CONSERVATION TEAM CONSULTATION APPLICATION RESPONSE

APPLICATION REF:	25/01124/FP & 25/01125/LBC
CASE OFFICER:	TR
APPLICATION SITE:	24A Bucklersbury, Hitchin, Hertfordshire SG5 1BG
DESCRIPTION OF WORKS:	FP - Insertion of rooflight to the existing rear roof pitch facing the existing integrated courtyard, installation of bi-fold glazing doors and sliding doors to the courtyard. Replacement of the existing corrugated fibre-cement roof. LBC - Internal and external alterations.

Proposed Section A

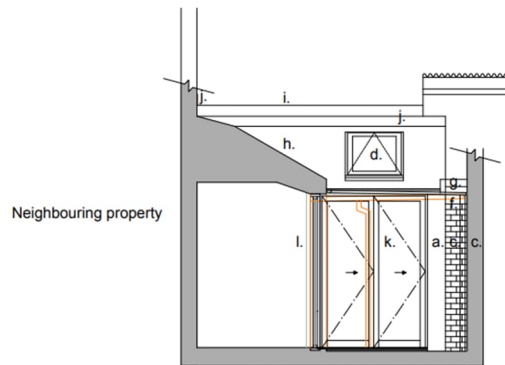
Having said that, whilst noting that there are two standard Velux type (as opposed to conservation-type) roof lights on the rear elevation it is disappointing that a similar roof

light type is proposed to the inner courtyard (see below). In my opinion, there are insufficient grounds to go back to the applicant requesting better quality conservation roof lights.
